Proposed Strategic Housing Development at Dunshaughlin East, Co. Meath

Stage 1-2 Road Safety Audit

- 1.1 Title** RSA DUNSHAUGHLIN S1-2
- 1.2 Audit Reference Number** RSA DUNSHAUGHLIN S1-2 KS 289
- 1.3 Project Code** DUNSGEMTIA
- 1.4 Date Audit Completed** 4th December 2018
- 1.5 Audit Attended By** Ken Swaby
Mark Andrews
- 1.6 Audit Team**
 - Team Leader** Ken Swaby, ILTP
 - Team Member** Mark Andrews, ILTP
- 1.7 Information Received**

Figure 4.1: Proposed Open Space Area and Adjoining Road Network (Source: JOR Drawing Road Signage & Markings Layout Plan Sheet 1 of 3, ref. 032, rev. 3)

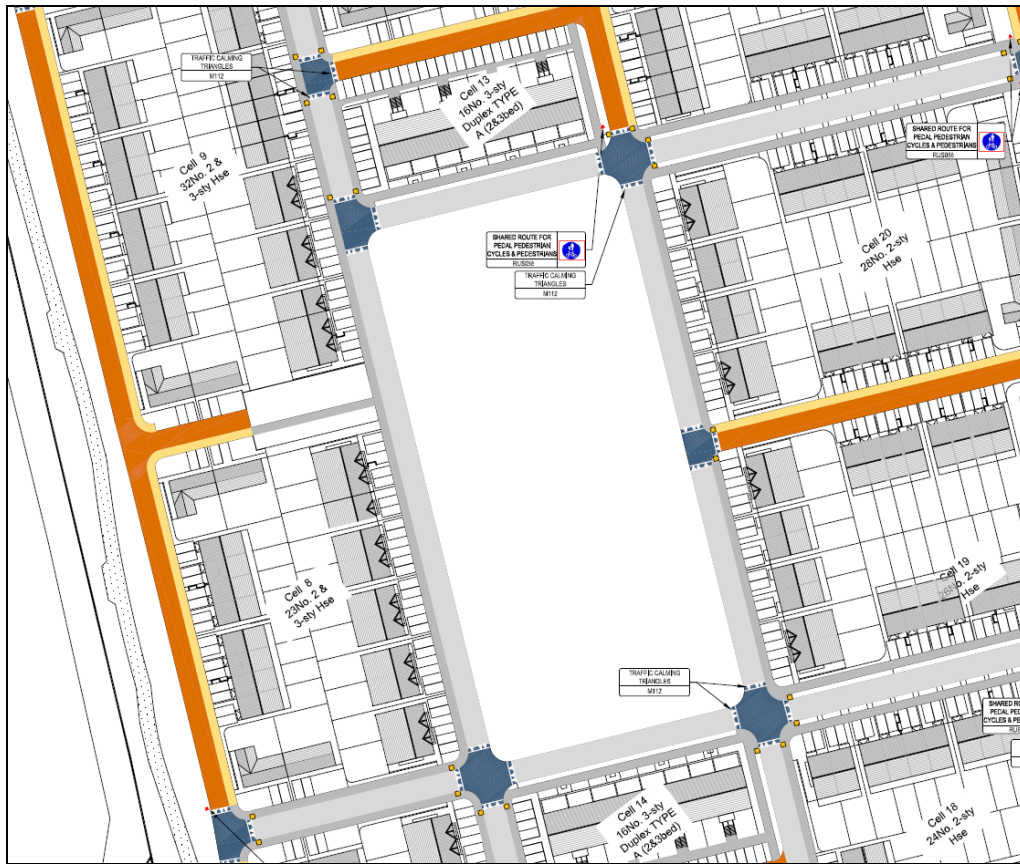
The drawings provided for audit indicate an Open Space area to the northwest of the proposals, but do not appear to include pedestrian access facilities in this area, such as footpaths adjoining the surrounding streets (refer Figure 4.1). Inappropriate or insufficient pedestrian facilities linking the proposed Open Space area and adjoining road network may potentially lead to non-motorised users entering the carriageway at an inappropriate location or time and coming into conflict with motorised traffic.

It is recommended that the design team ensures that appropriate pedestrian facilities are provided within and around the proposed Open Space area.

4.1.6	Y	Y	<p>The design team agree with the recommendations.</p> <p>Pedestrian facilities linking the proposed open space area and adjoining road network will be incorporated in the scheme.</p>	Y
